Easton Staff Development Review MEETING AGENDA

| | Request: | Sketch Site Plan and Stormwater Management review of a proposed warehouse and climate-controlled self-storage building with associated parking and landscaping. |

DATE: October 25, 2023
TO: Daniel Lerian - Owner
cc: Sierra Clem - Town of Easton Engineering Department
FROM: Rick Van Emburgh, P.E. – Town Engineer
SUBJECT: Blue Crab Self Storage LLC
Sketch Site Plan Review

SHEET 03 OF 03

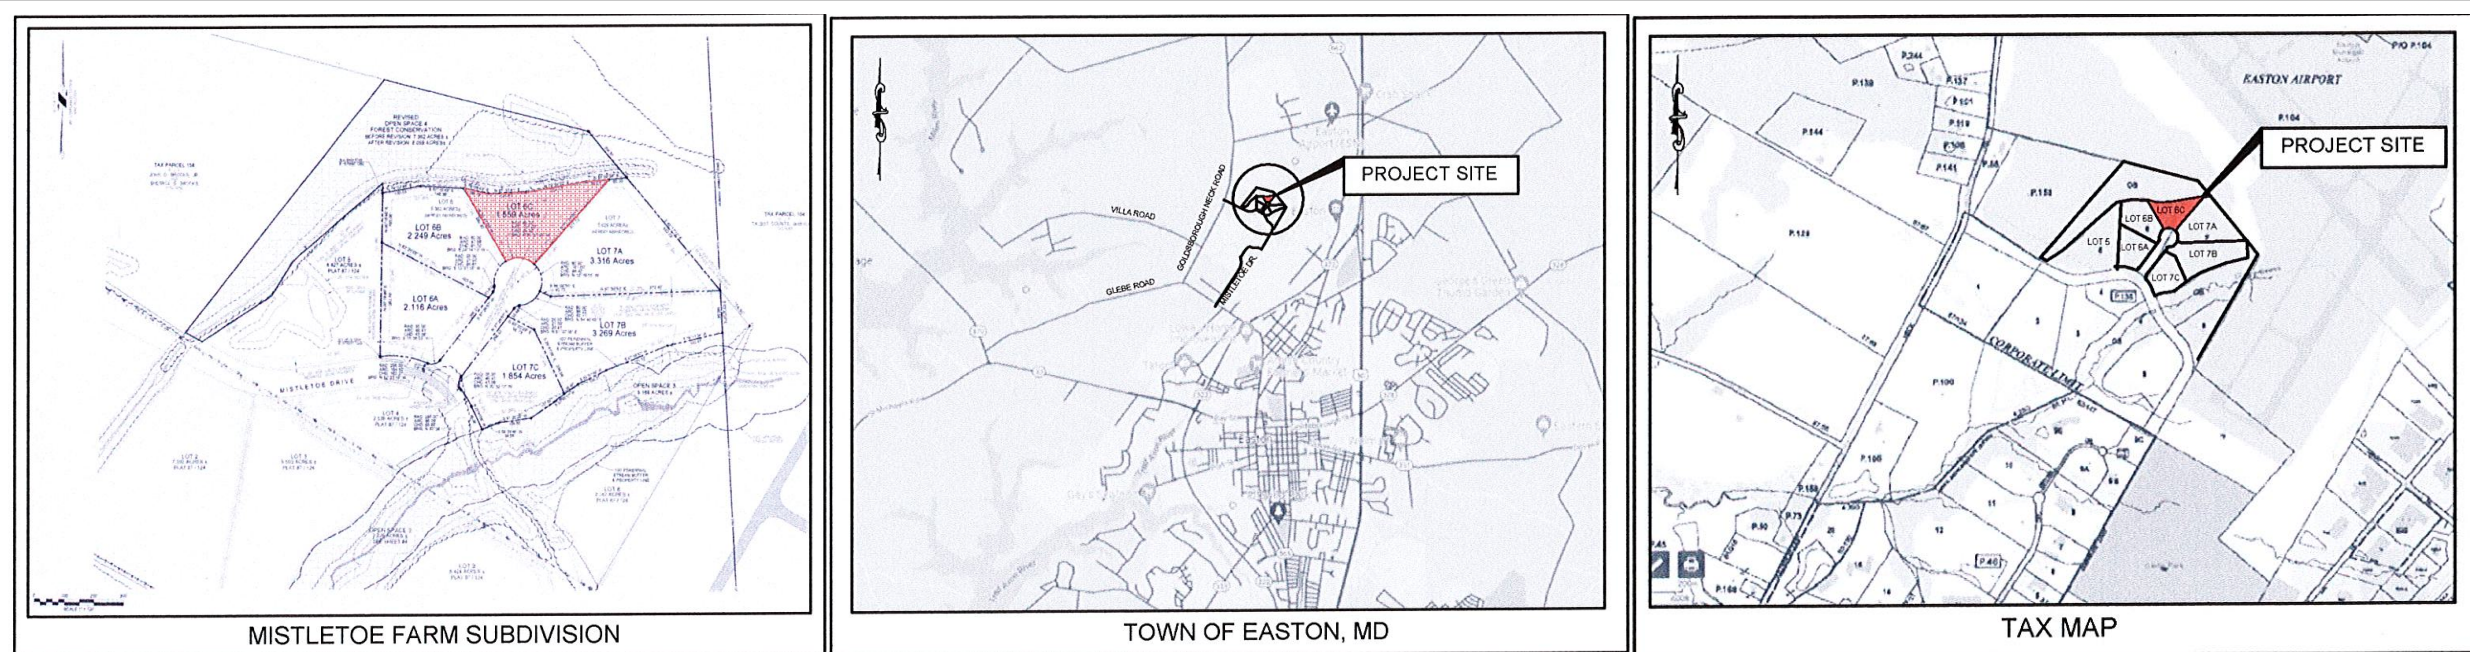
1. **SHEET 3 OF 3** - Quantity Summary Chart - Both Summary Charts are labeled "ESD SUMMARY CHART". The chart with quantity management information should be labeled "QUANTITY SUMMARY CHART". **Comment acknowledged. The table title has been changed**
2. **SHEET 3 OF 3** - It appears there is an increase in flow. The 2-year and 10-year storms must be managed. **See response below**

We have provided a response (attached) to Comment #2, above. We are demonstrating in the attached report and calculations that there will be no increase in flow for the 2-year and 10-year storms.

Comment #2 commented on what was shown on the plans (sheet 3 of 3) as an increase between the pre- and post-development flow for each of the three drainage areas that are to drain to the three practices proposed for stormwater management (SWM). The three proposed practices consist of a micro bioretention area (MBR), along the north boundary of the project area, and two (2) wet-soil rain gardens (WSR#1 and WSR#2) along the southern limits of the project area.
